Public Input No. 2766-NFPA 70-2020 [Global Input]

Clarify terminology of power system types and power supply system types.

Emergency Sources TG – Case 2, Emergency and other load

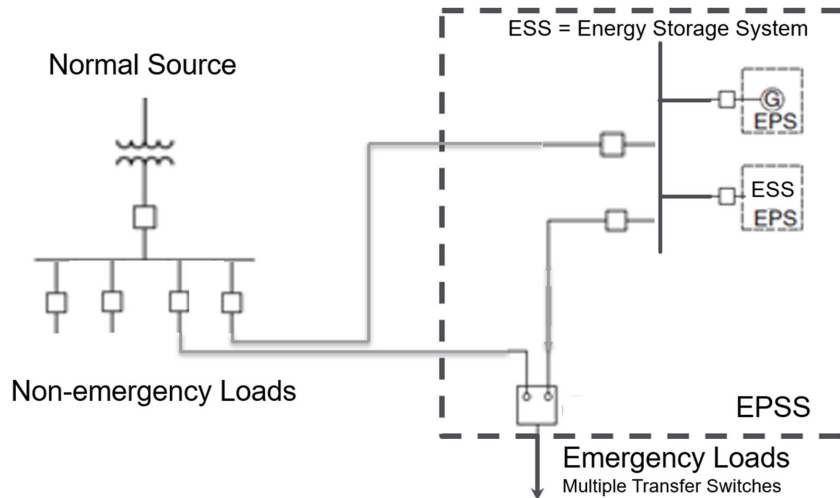
The final paragraph provides and allowance that where a stored-energy emergency source, such as a battery or ESS, is used as part of the emergency power system, it shall be permitted to be charged by other sources, not just those categorized as emergency sources. This is not a blanket allowance however, since an analysis must be performed to ensure that the lack of any of these sources, or any failure within them, will not impact the ability of the emergency system to supply the emergency loads.

**Figure Informational Note Figure
700.32 Emergency System Selective
Coordination.**

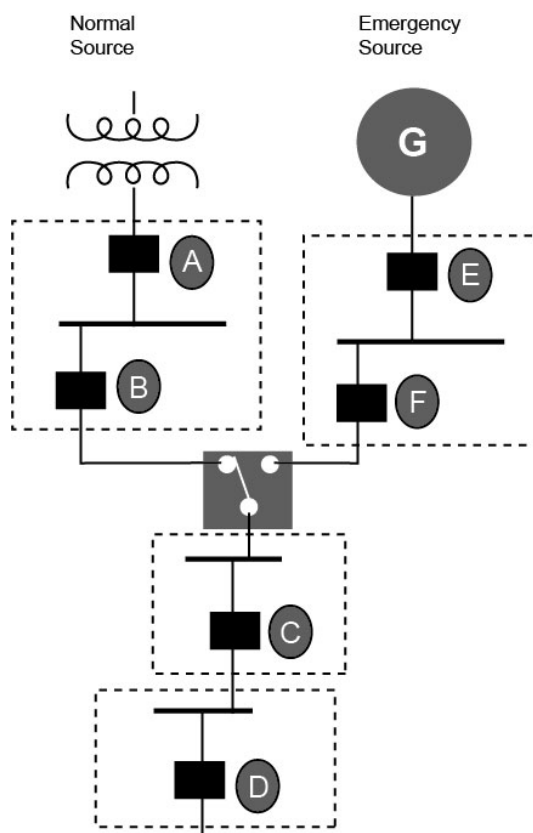
OCPD ~~F~~ B selectively coordinates with OCPD ~~E~~ A. OCPD ~~B~~

Selective coordination is not required to ~~selectively coordinate with OCPD A because OCPD B is not an emergency system OCPD.~~ for non-emergency loads.

**Figure Informational Note Figure
700.32 Emergency System Selective
Coordination.**

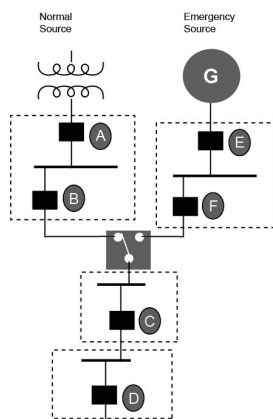
OCPD C and D need to be coordinated to the higher available fault current from either the normal or emergency source.

**Figure Informational Note Figure
700.32 Emergency System Selective
Coordination.**

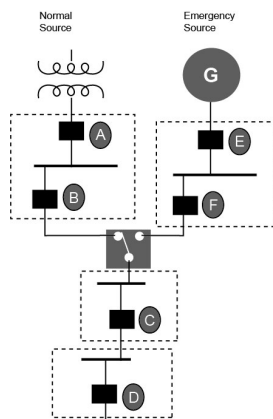
The entire system must coordinate as indicated above beginning with the OCPD closest to the emergency load and working upstream to the supply-side source(s).
Modifications of any OCPD in the source path require all OCPD in the path to be evaluated to ensure selective coordination is maintained.

**Figure Informational Note Figure
701.32 Legally Required Standby System
Selective Coordination.**

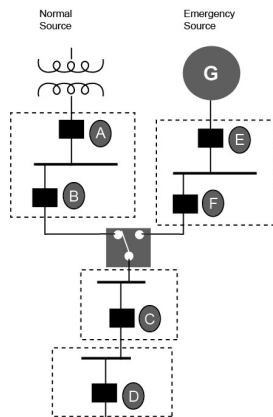
The entire system must coordinate as indicated above beginning with the OCPD closest to the emergency load and working upstream to the supply-side source(s). Modifications of any OCPD in the source path require all OCPD in the path to be evaluated to ensure selective coordination is maintained.

Figure Informational Note Figure 708.54 Critical Operations Power System Selective Coordination.

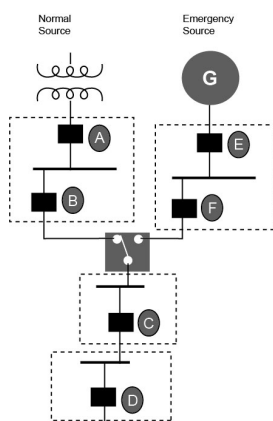
[modify this section to match the changes shown for 700.32.](#)
